Recommendation to Hold a Public Hearing and Approve the 108-110 Ritchie Lot Line Shift Final Plat & Findings of Fact, Conclusions of Law, and Decision.

A PLAT SHOWING LOT 3A, BLOCK 4, WARM SPRINGS VILLAGE 2ND ADDITION REVISED

IN RE:)	
)	
108-110 Ritchie Lot Line Shift)	KETCHUM CITY COUNCIL
Lot Line Shift)	FINDINGS OF FACT, CONCLUSIONS OF LAW, AND
Date: July 18, 2022)	DECISION
)	
File Number: P22-027)

LOTS 3A, BLOCK 4, WARM SPRINGS VILLAGE 2ND ADDITION REVISED

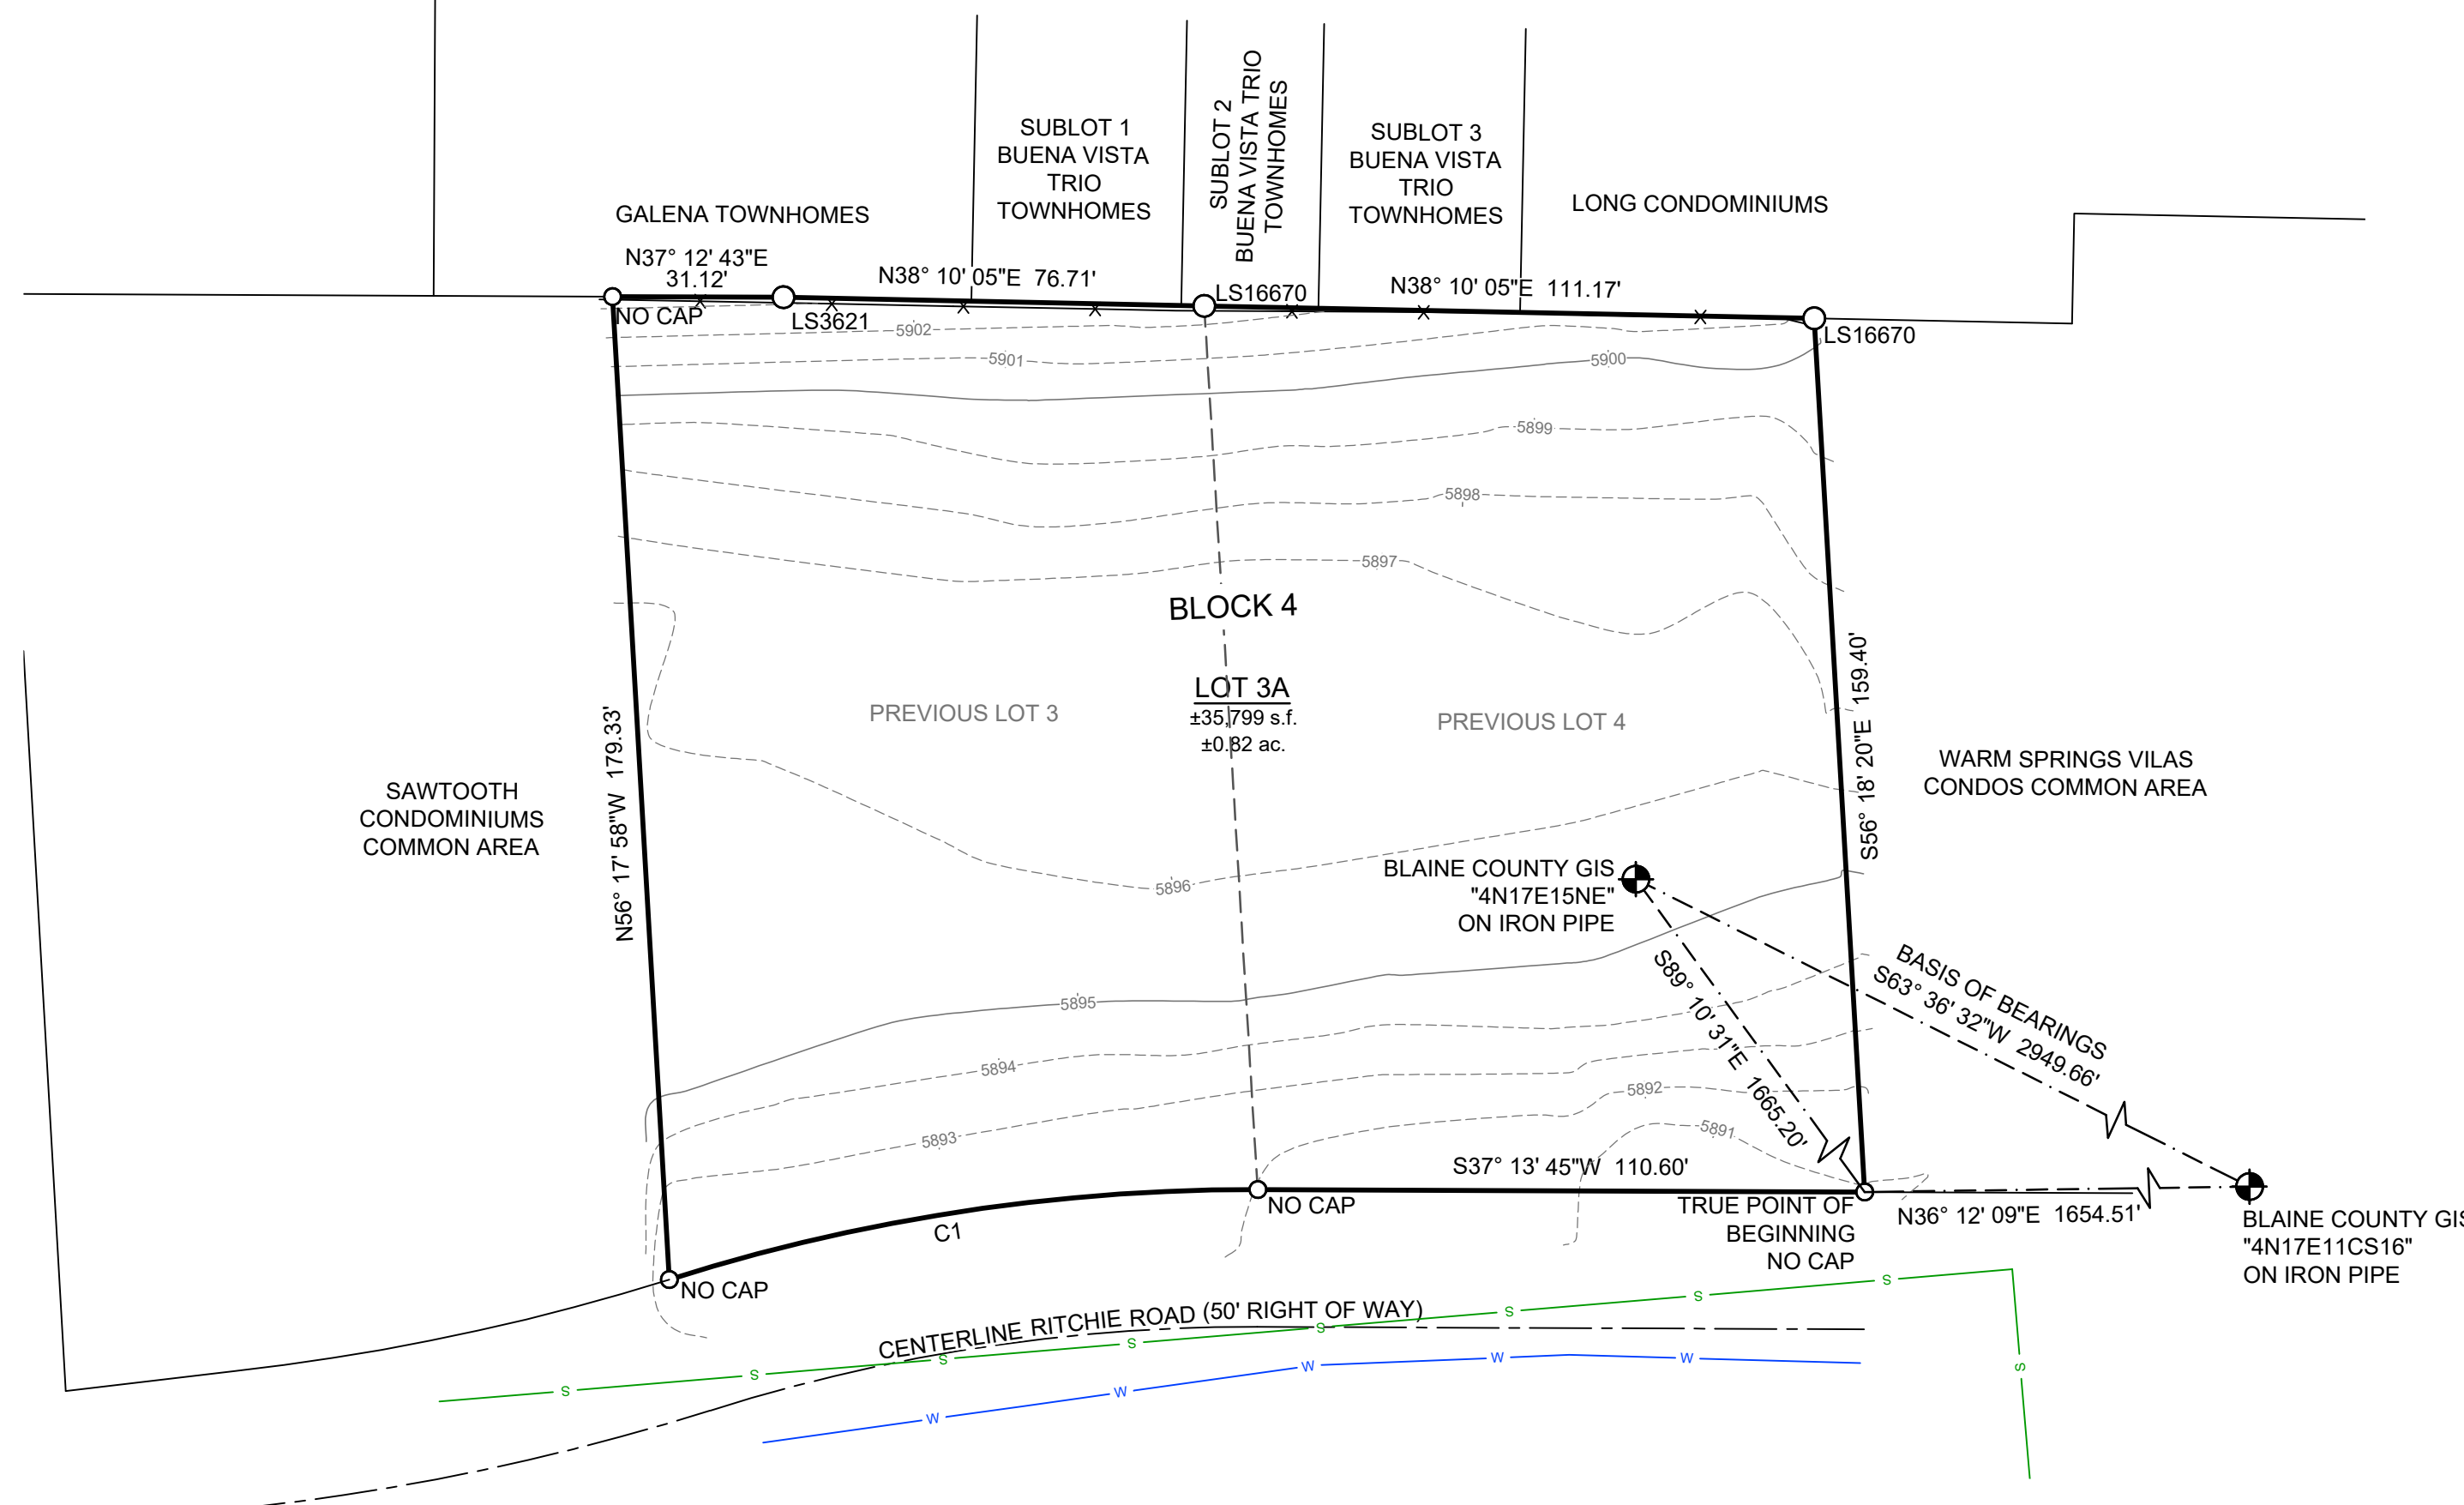
Council Findings	<i>Standard #1 has been met. Lot 3A complies with the dimensional standards required for lots within the T - 3000 Zone. Standards #3-6 are not applicable</i>
<input type="checkbox"/>	<input type="checkbox"/>	<input checked="" type="checkbox"/>	16.04.040.G	<p>G. Block Requirements: The length, width and shape of blocks within a proposed subdivision shall conform to the following requirements:</p> <ol style="list-style-type: none"> 1. No block shall be longer than one thousand two hundred feet (1,200'), nor less than four hundred feet (400') between the street intersections, and shall have sufficient depth to provide for two (2) tiers of lots. 2. Blocks shall be laid out in such a manner as to comply with the lot requirements. 3. The layout of blocks shall take into consideration the natural topography of the land to promote access within the subdivision and minimize cuts and fills for roads

3. The recorded plat shall show a minimum of two Blaine County Survey Control Monuments with ties to the property and an inverse between the two monuments. The Survey Control Monuments shall be clearly identified on the face of the map.

1. The amended plat mylar shall meet all conditions specified in Table 1: Findings Regarding Contents of Final Plat and Subdivision Design & Development Requirements.
2. The amended plat shall meet all governing ordinances, requirements, and regulations of the Fire Department (2012 International Fire Code and local Fire Protection Ordinance No. 1125), Building Department (2012 International Building Code, the 2012 International Residential Code, and Title 15 of Ketchum Municipal Code), Utilities Department, Street Department (Title 12 of Ketchum Municipal Code), and the City Engineer.
